W31: IH-10 Boerne Stage to Old Fredericksburg Sanitary Sewer

Job No.: 09-2502

ADDENDUM 2

October 4, 2016

SHEET NUMBER	C - 45
SHEET	98 OF 135

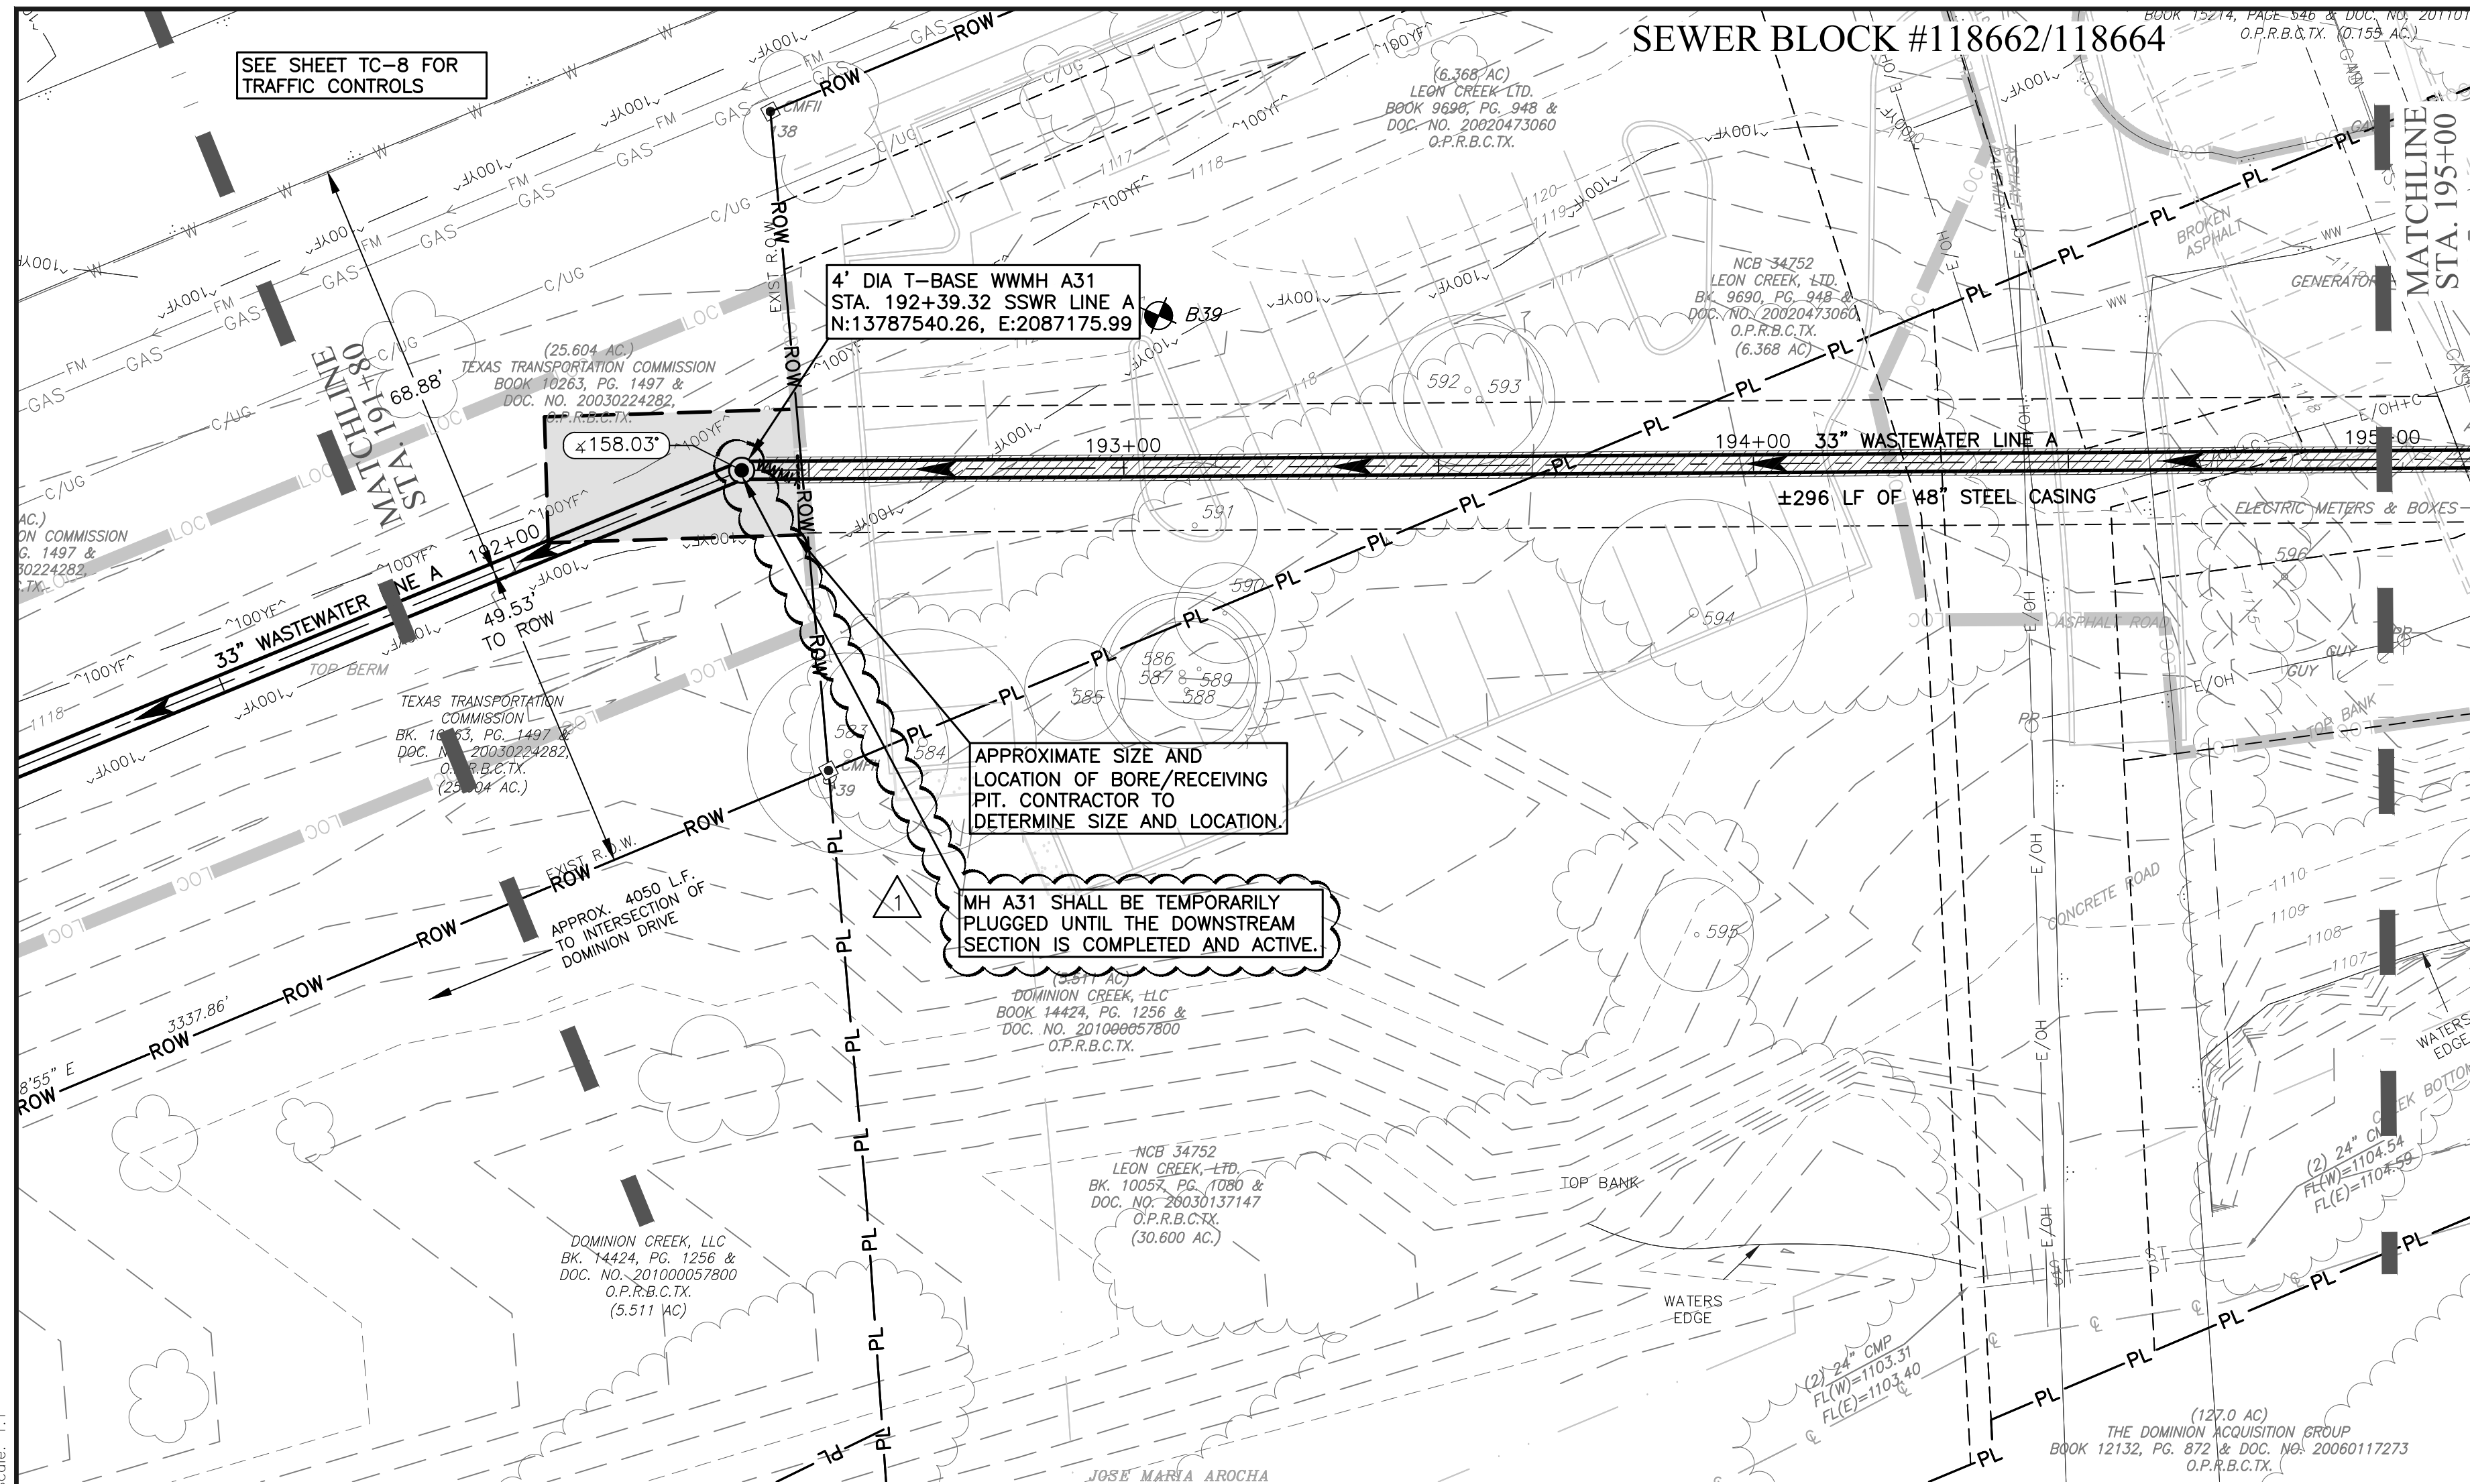
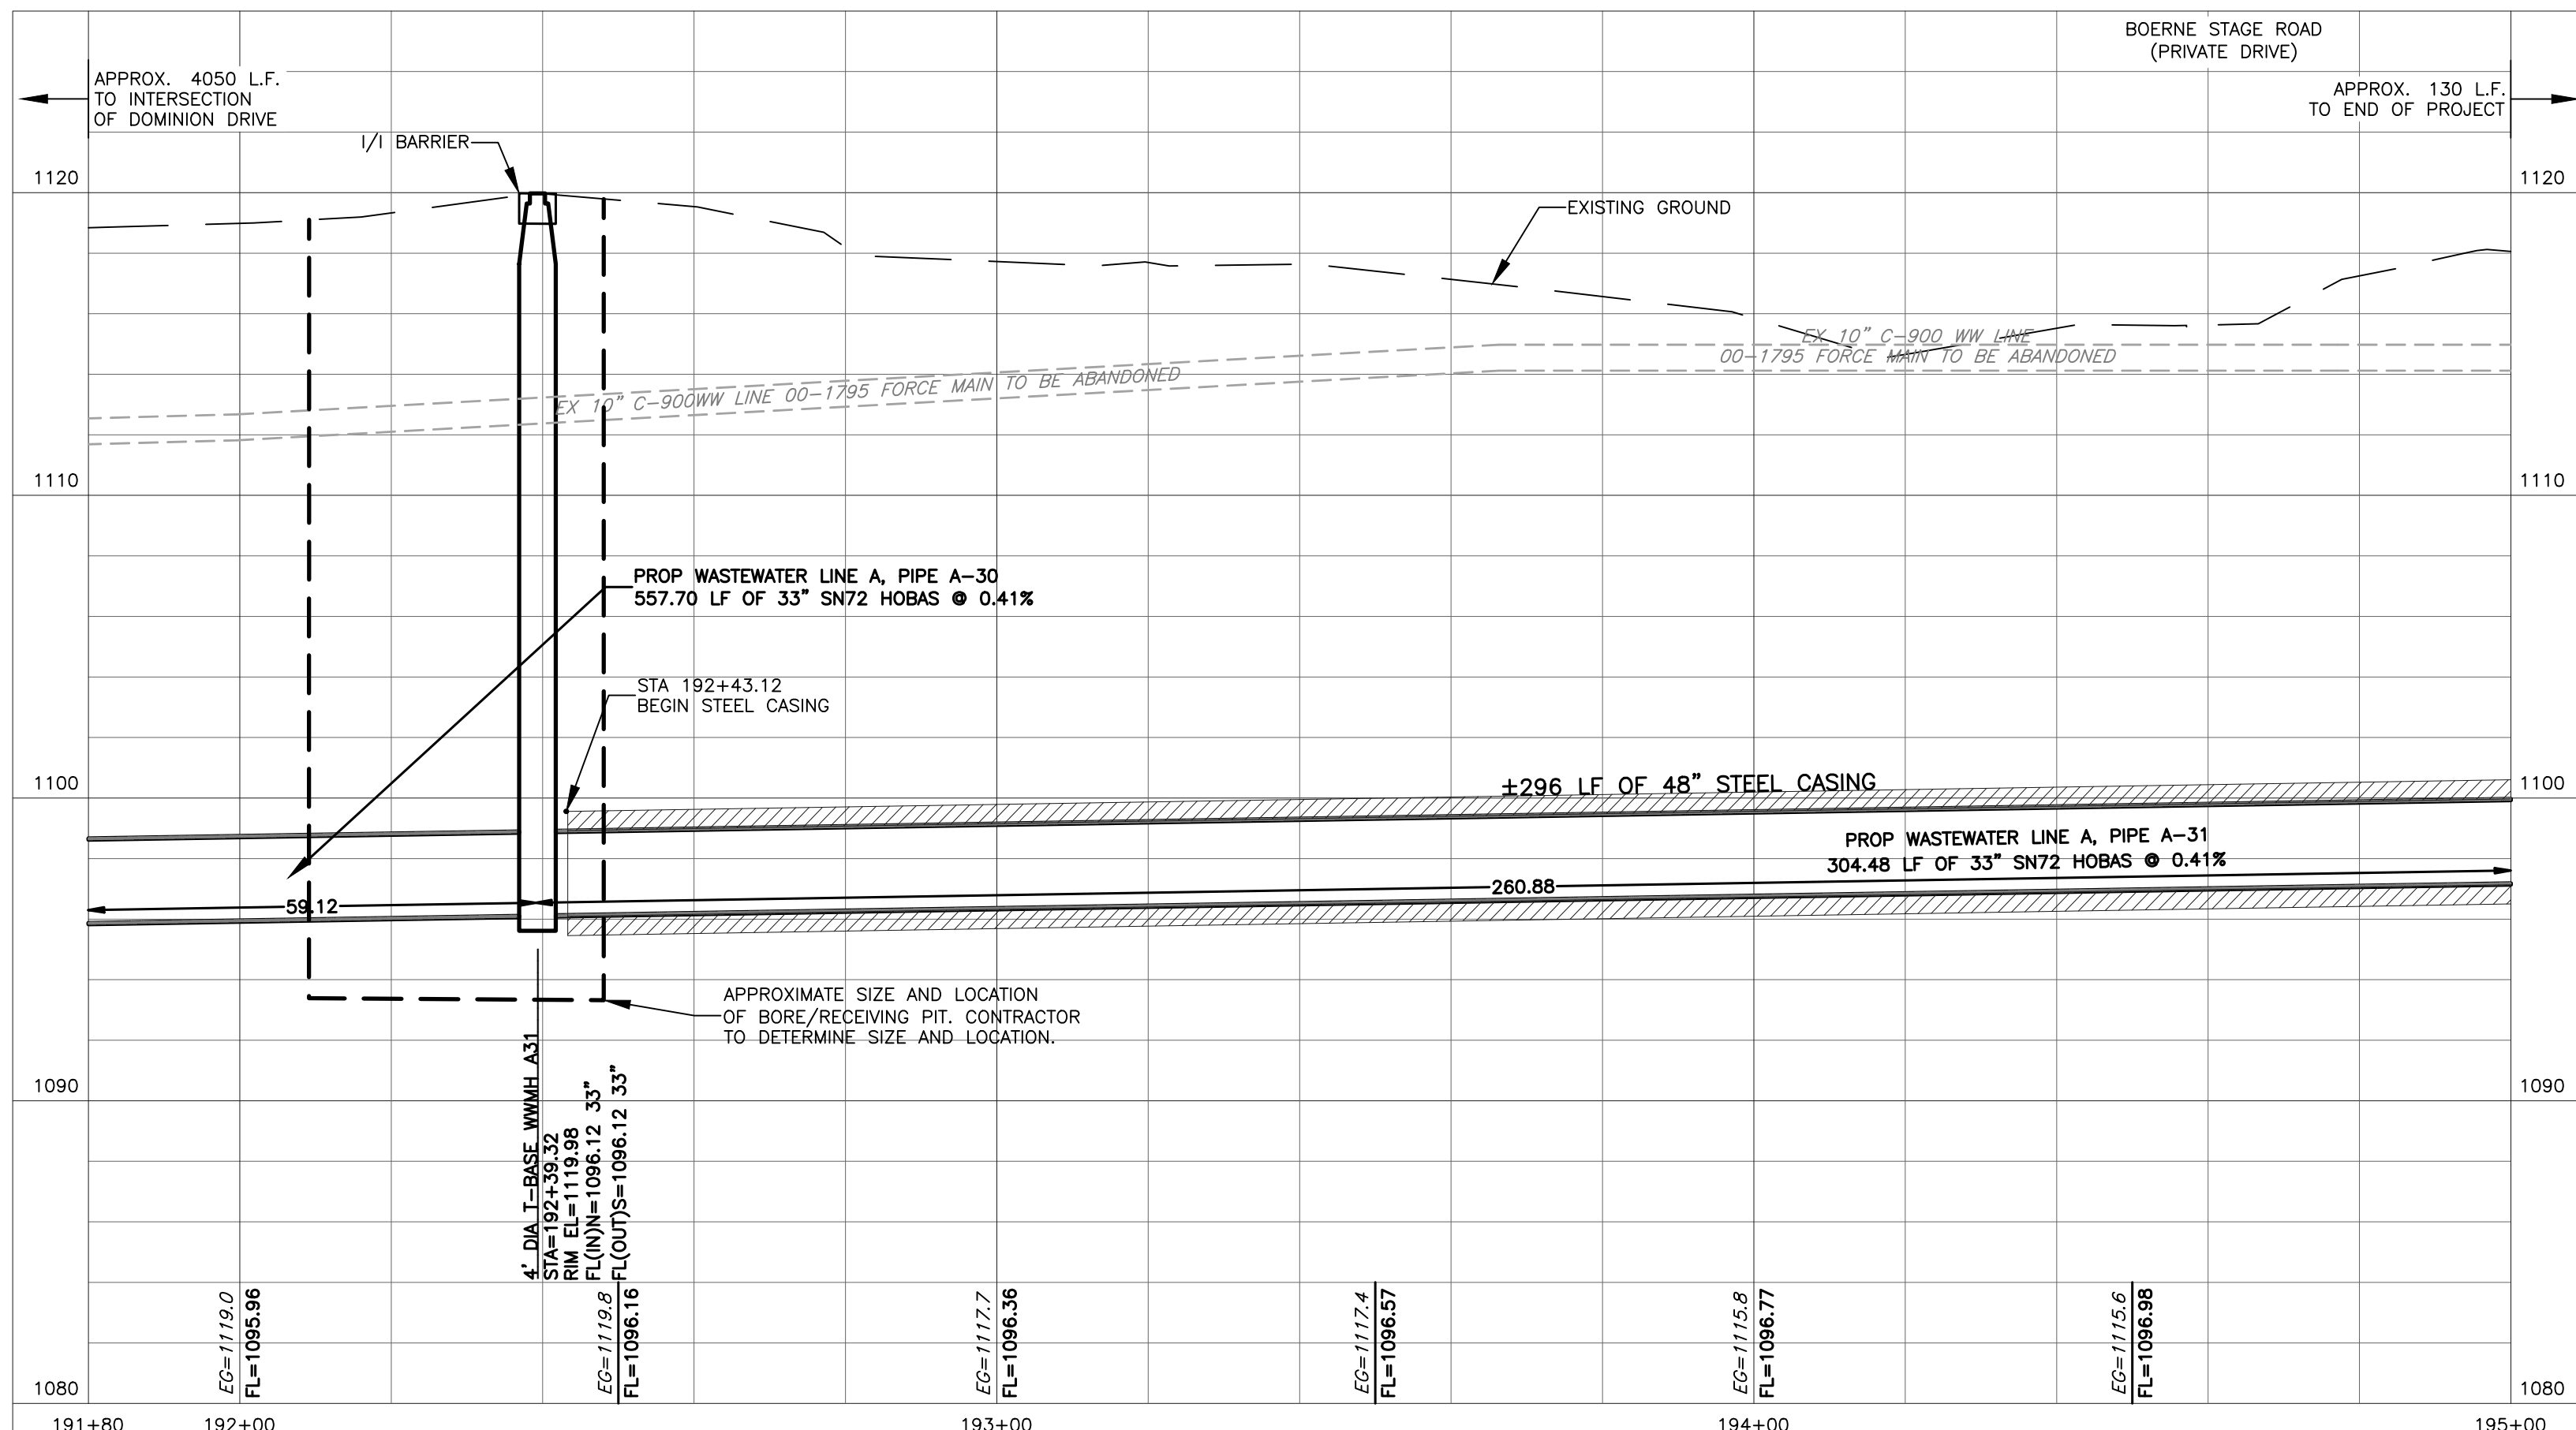
3. The following note was added to Sheets C-9, C-10, C-12, C-13, C-14, C-15, C-45, and C-46:

"The Contractor shall provide the property owner a written notice of initial entry 10 days prior to start construction within their property."

5. On Sheet C-45, the following note was added:

“MH A31 shall be temporarily plugged until the downstream section is completed and active.”

SPECIAL NOTE:
 1. THE CONTRACTOR SHALL PROVIDE THE PROPERTY OWNER A WRITTEN NOTICE OF INITIAL ENTRY 10 DAYS PRIOR TO START CONSTRUCTION WITHIN THEIR PROPERTY.
